1 **1.0 Introduction**

2 Manitoba Hydro's Rebuttal Evidence addresses the written evidence filed by Whitfield Russell
 3 Associates ("WRA") on behalf of the Manitoba Métis Federation with respect to the Needs For
 4 and Alternatives To review of Manitoba Hydro's Preferred Development Plan ("PDP"). Through
 5 these sections of the rebuttal evidence, Manitoba Hydro will justify the reliability of the
 6 proposed PDP.

FIGURE 1: POWER SURPLUS/DEFICIT FOLLOWING LOSS OF BP I/II AT WINTER PEAK.

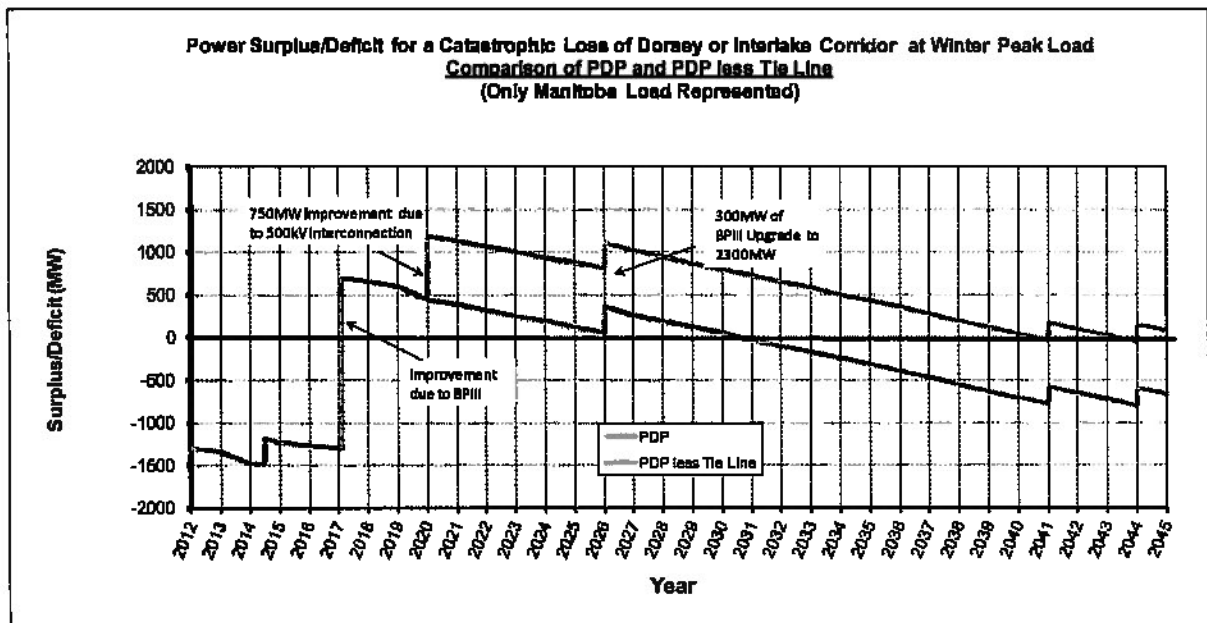
16 WRA contends in MH/MMF/WRA-004a (lines 130-133) that "...Manitoba Hydro will be deficient
 17 in import capacity under its assumptions for 2019/2020 and 2020/21 if Keeyask enters service

1 on schedule but completion of the second 500 kV ac line is delayed.” This conclusion is
2 unfounded, as Manitoba Hydro’s calculations shown in Figure 1, demonstrate that a delay in
3 the new 500 kilovolt (kV) tie line of one year will not result in a power deficit.

1 WRA states the following in MH/MMF/ WRA-004a (lines 111-112): "...Manitoba Hydro does not
 2 intend to comply with the deterministic criterion it espoused in the CEC proceeding on Bipole
 3 III." While the NFAT proceedings have focused on other criteria, an assessment of the ability of
 4 the PDP to serve Manitoba load during the loss of Bipoles I and II was in fact conducted. The
 5 figure below indicates the ability of the PDP to supply Manitoba load to 2045. In 2041 and
 6 beyond, it is assumed gas turbines will be added in southern Manitoba to supply future load
 7 growth and ensure minimal power deficits.

11 A key component of the PDP that ensures reliability for this extreme event is the addition of the
 12 750 MW tie line. Without the tie line, a deficit is expected as early as 2025⁶. This deficit was
 13 also identified in the Bipole III CEC proceedings.
